Date: November 4, 2019  
To: Beth Callahan, Project Manager, Maine Department of Environmental Protection  
Karem Gungor, Environmental Engineer, Maine Department of Environmental Protection  
From: Elizabeth M. Ransom, P.G. Ransom Consulting, Inc.  
Subject: Nordic Aquafarms, Inc., Land-based Aquaculture Facility, Belfast, Maine  
L-28319-26-A-N, Review Comments

Project No.: 171.05027

SCALE: AS SHOWN  
PROJECT MANAGER: ASB PROJECT NO.: 19019  
DATE OF RECORD: 5/14/19  
JOB CAPITAL: SP  
DRAWN BY: AJL  
CHECKED BY: CE111  
SHEET NO.: 11  
SHEET TOTAL: 11  
NOT FOR CONSTRUCTION

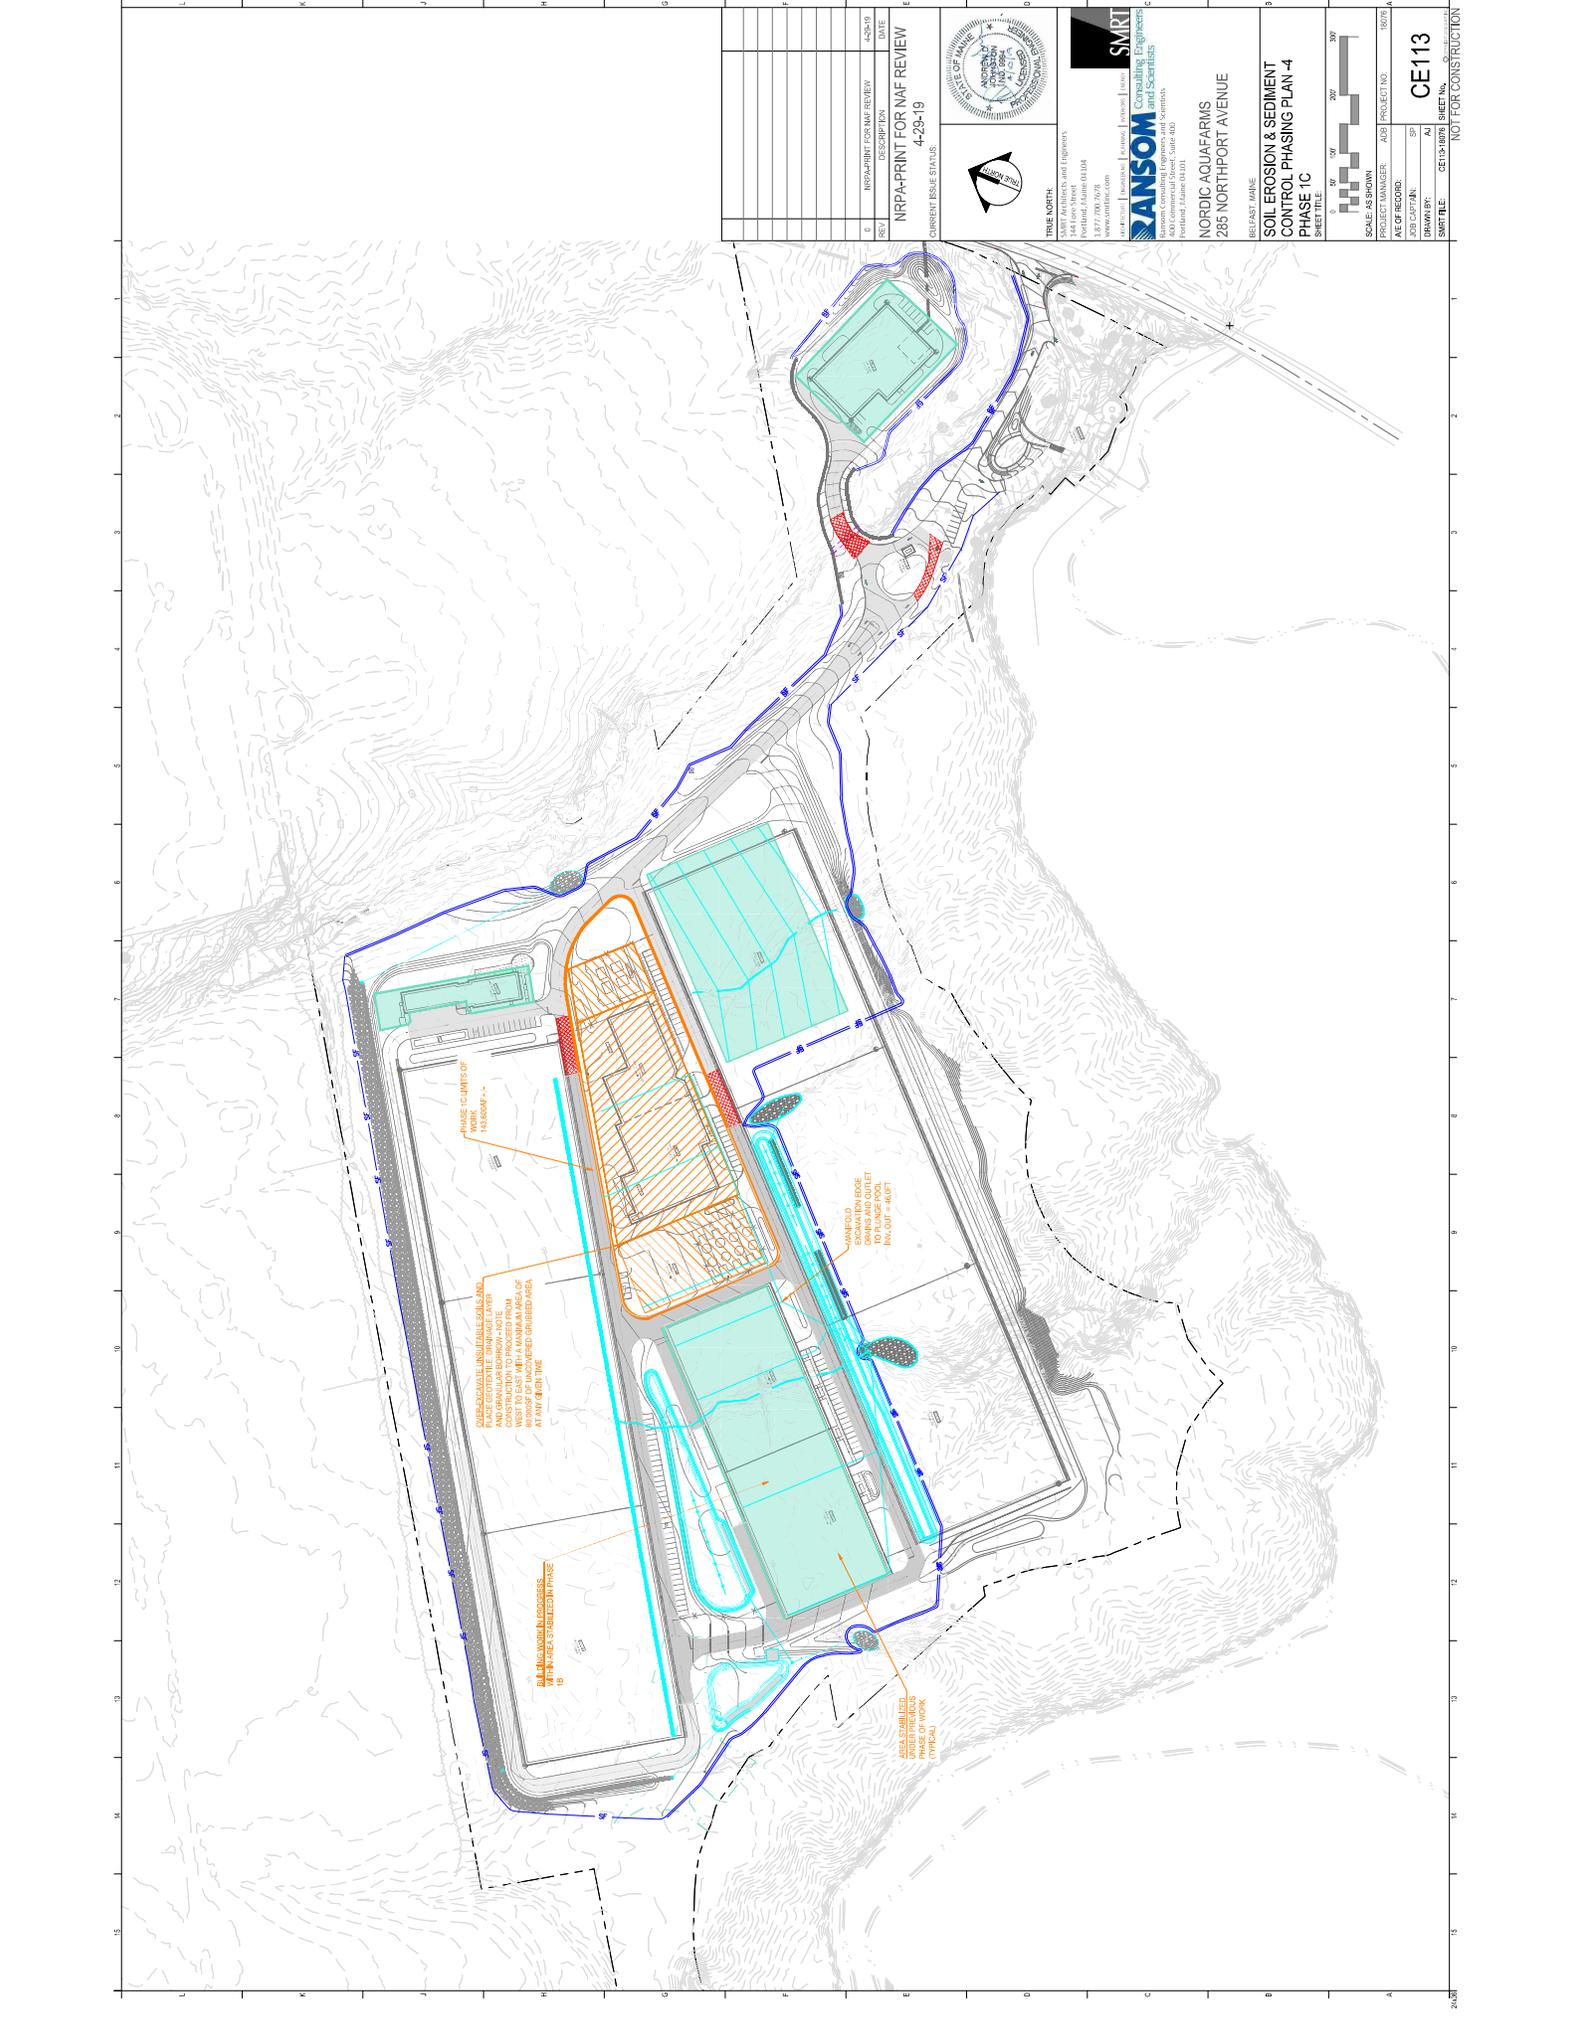
*1. First Diversion Trench (Sheet CE111): This trench will not be connected to the edge drain/culvert bypass system as shown in the ESC phasing plans. The trench will intercept the surface runoff from approximately 8.5 acres of upgradient area (see south of Subcatchment 9 flow path in Sheet CW-102) which appears to shed into the streams S3, S5, and S6 under the existing/pre-development conditions. The intercepted flow (surface runoff+ groundwater) will be discharged into an easterly plunge pool based on the underdrain invert elevations provided in Sheet CE111. I recommend the following:*

*a. Connect the trench underdrain to a bypass culvert or bypass culverts so that the intercepted flow is conveyed southerly and contributes to the baseflow provided for the streams S3, S5, and S6 under the post-development condition,*

*b. Eliminate the westerly and easterly outfalls of the trench underdrain shown in Sheet CE111. The outfalls may be necessary during the initial phases of the project; but they need to be removed or*

*deactivated post construction to simulate the pre-development site hydrology to the extent practicable and mitigating the project's hydrologic impact on the jurisdictional streams,*

1a. A new extended bypass drain has been added to the plans during Phase 2A of the project. The Phase 1 outlets will be eliminated, and the new drain system will convey flows around the site to discharge at Streams S3, S5, and S6, as requested.
